DR2E Corrections

HF I/Q SDR Receiver DR2E
30 kHz-40 MHz YU1LM/QRP

HF I/Q SDR Receiver DR2E Rev1

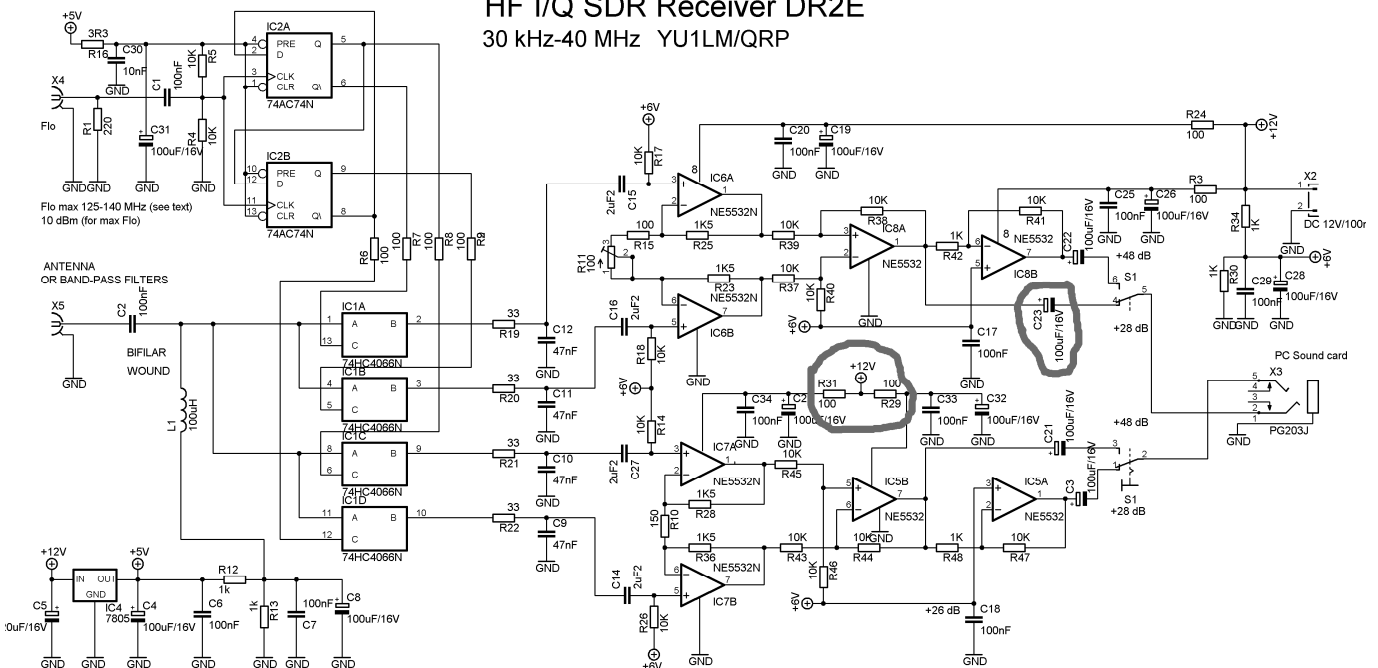
I missed connection for power supply IC7, IC5 and output C23 100uF. Corrected new version of PCB and Schematic are down.
